OB-8

SCHEMATIC 1679A SHEET 2

ENGINEERING CHANGE ORDER

1679 B - SHEET 1

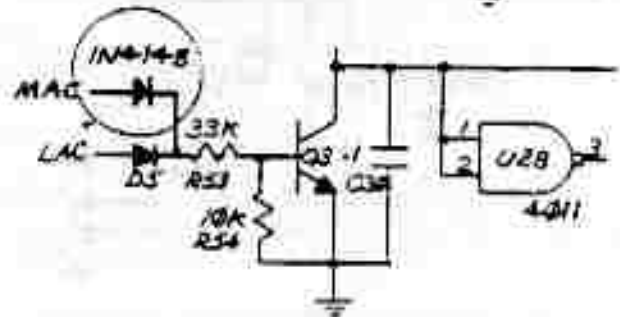
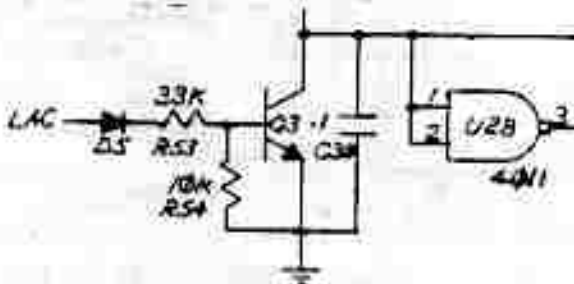
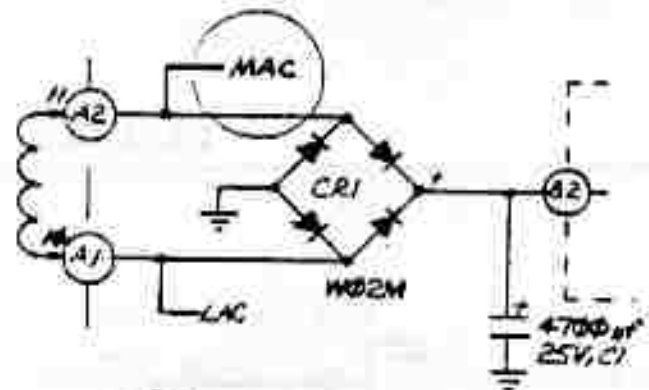
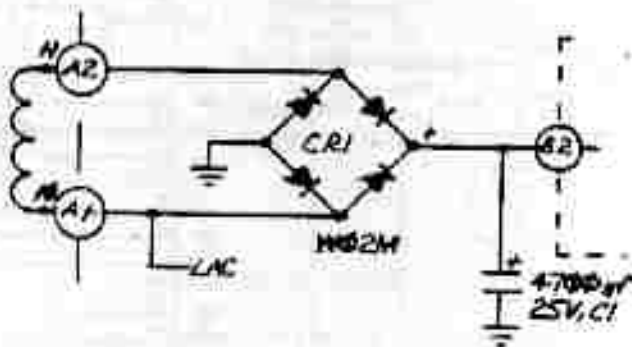
IMPROVE MARGIN OF "PUP" CIRCUIT TO INADVERTENT TURN-OFF, ESPECIALLY AT 50 KHz.

PROCESSOR BOARD 1679B SHEET 1 OF 4

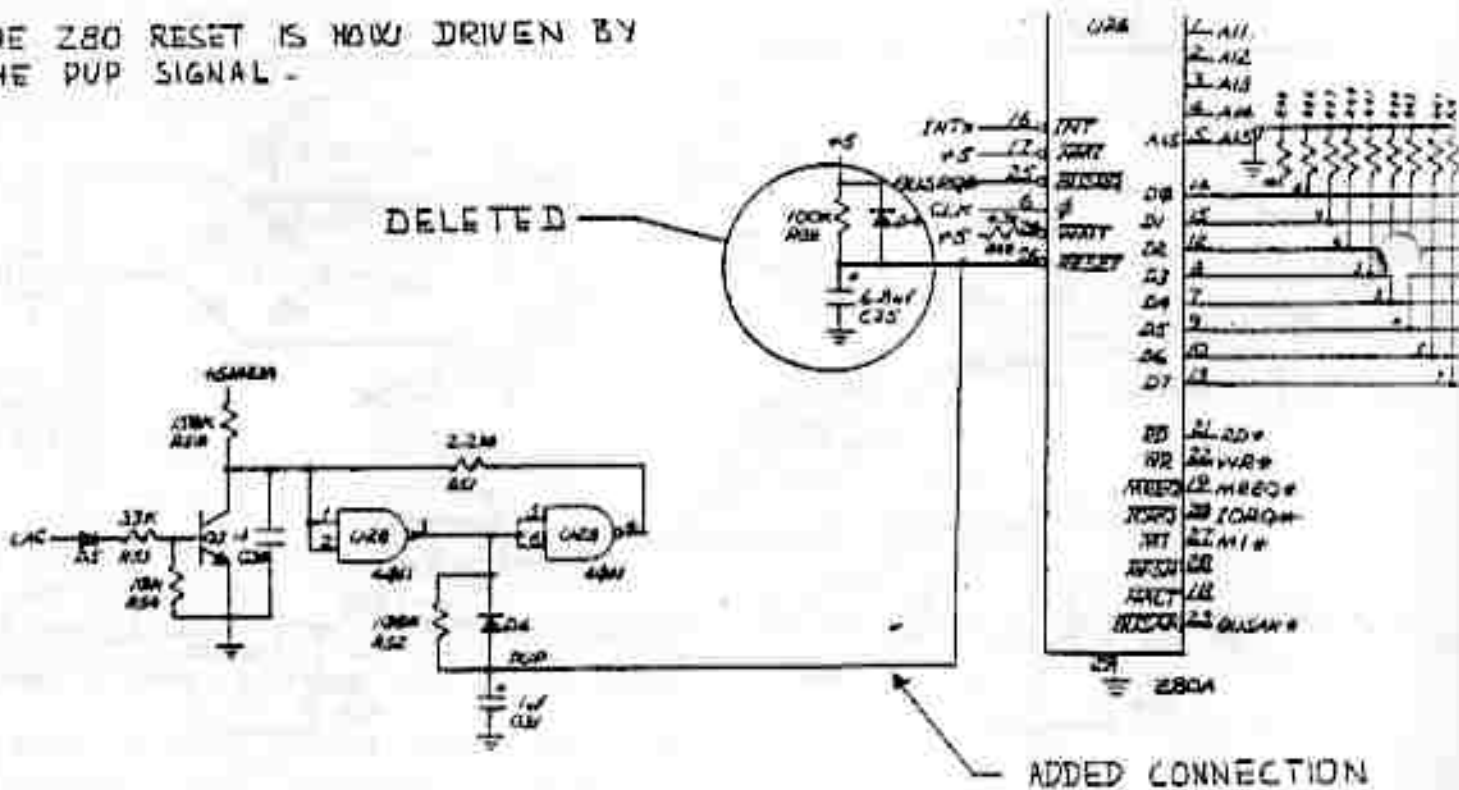
THE Z80 RESET IS NOW DRIVEN BY THE PUP SIGNAL -

TO AVOID POSSIBLE MEMORY DROP CAUSED BY SHORT POWER DROP

DRAWINGS AFFECTED  
POWER SUPPLY

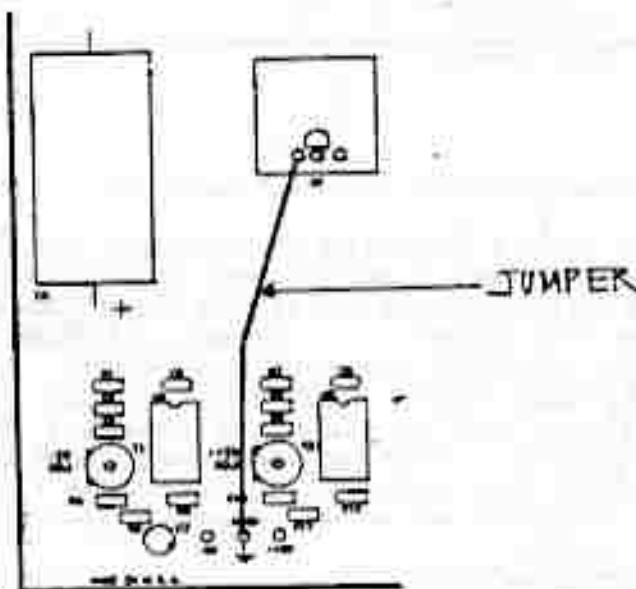
ADD A JUMPER BETWEEN PIN 1 OF THE -15 REGULATOR  
7915 (GND) AND THE GROUND REFERENCE TEST POINT.  
THE JUMPER MUST BE MADE OF A 18 AWG WIRE (.04 inch / 1 mm)  
MINIMUM AND MUST BE SHORT.

TO REMOVE AC HUM ON AUDIO OUTPUT.

OB-8 PROCESSOR BOARD 1679B sheet 1 of 1

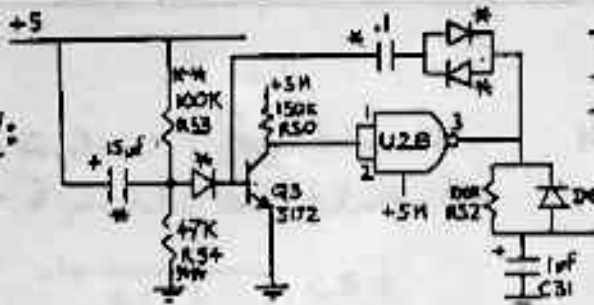
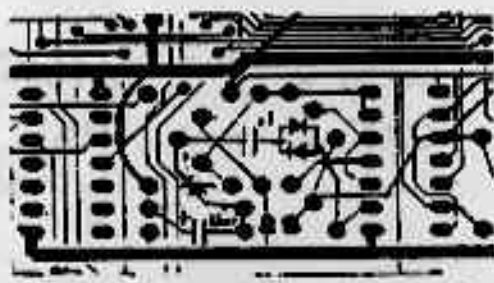
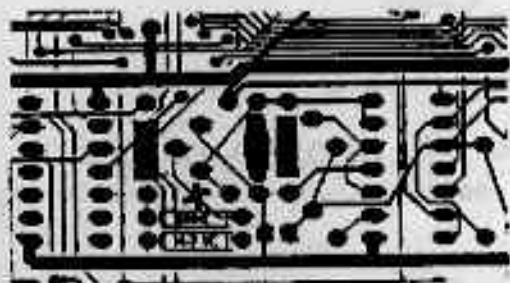
NEW PUP CIRCUITRY:

PUP To memory protect and processor reset (see ECO #424)

- Remove D5, C30, R31 (parted components)
- Cut between Q3 base and R53
- Remove diode added by ECO #23 (under the board)
- Replace R53 with a 100K and R54 with a 47K

- Add a jumper between +5 and R53
- Add from under the board: 2 caps and 3 diodes

- Replace C1 (4700µF cap. on 5v power supply) with a 10,000µF 16v

- Avoid memory drop.

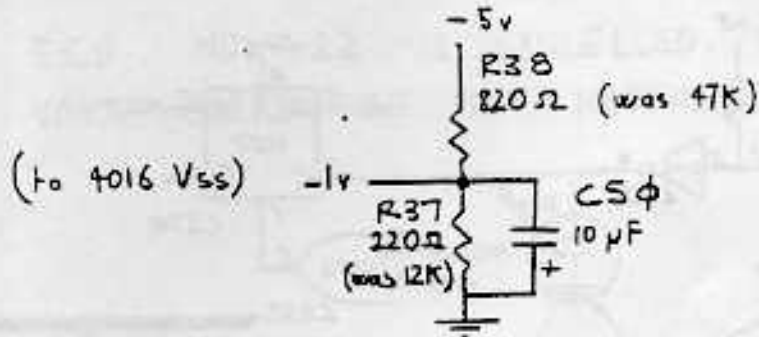
- change value of -1 divider on each voice board

08-8 MOD CAN SCHEMATIC  
SHEET 1 OF 1.

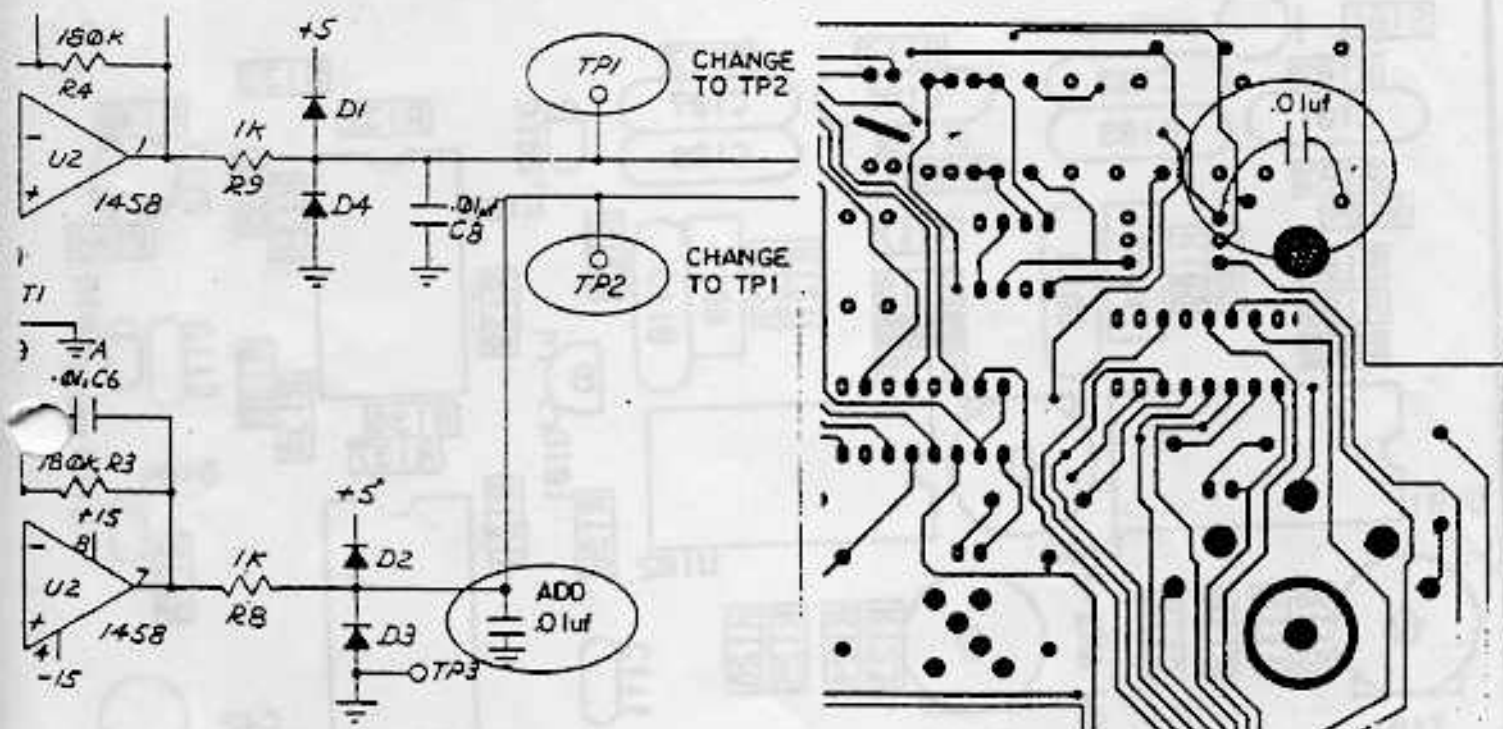
REMOVE NOISE MODULATION FROM  
VIBRATO LEVER, AND CORRECT  
SCHEMATIC.

1. CHANGE SCHEMATIC AS SHOWN.
2. ADD .01uf CAP (08.153004) FROM GROUND TO TEST POINT (T.P. 2) OF MOD CAN PCB ON 1666 SIDE OF BOARD.

DRAWINGS AFFECTED VOICE BOARD  
SCHEMATIC 1682B SHEET 3 OF 3

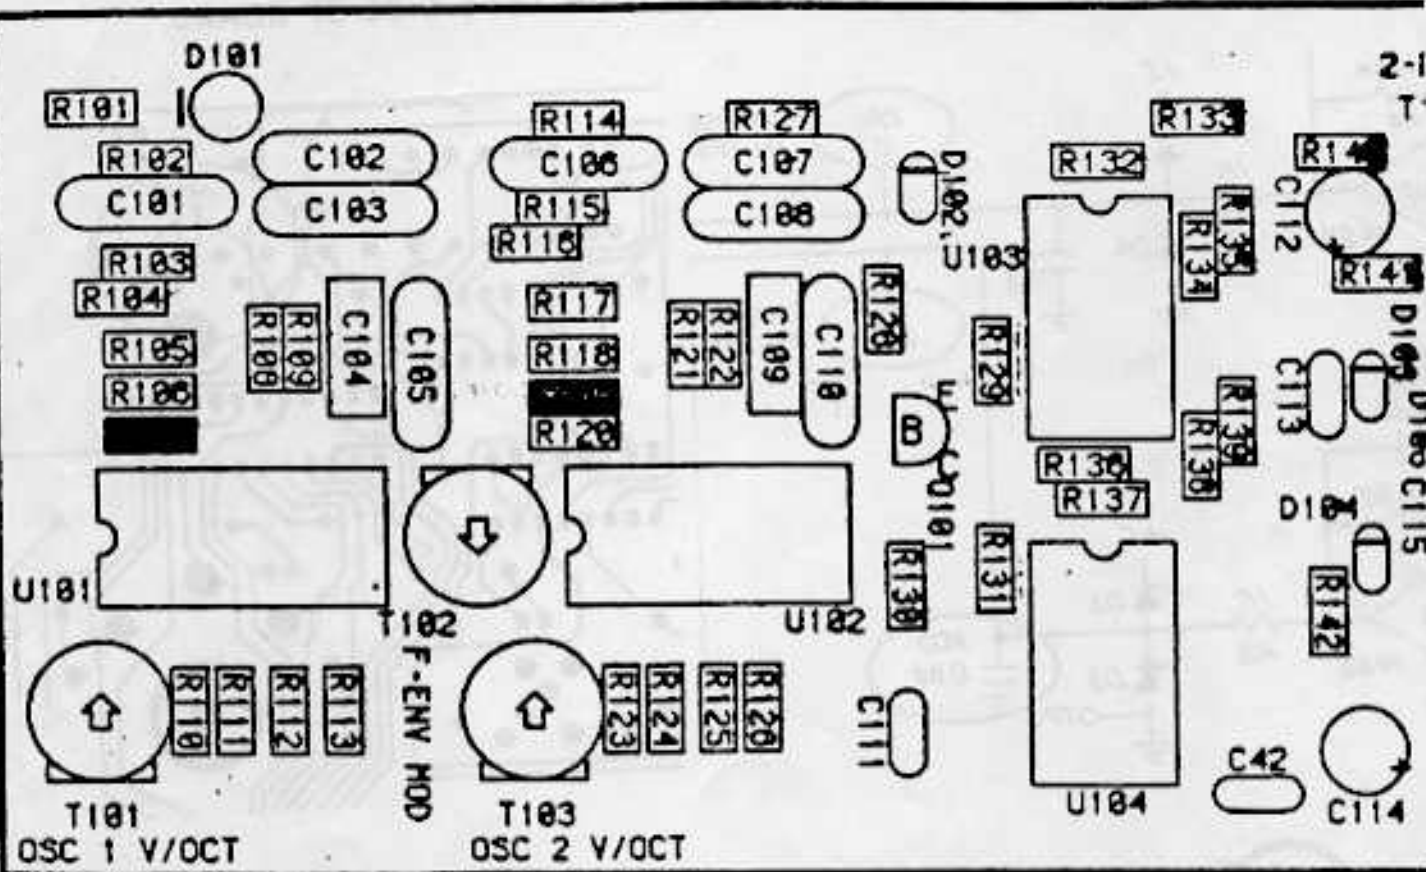
LOWER INITIAL FREQUENCY OF 3340  
TO ACCOMMODATE A WIDER RANGE  
OF CHARACTERISTIC VARIATIONS ON  
THE 3340.

REPLACE RESISTOR RX07 AND RX19 (215K, 1%)  
WITH 174K, 1% (OB#475520).
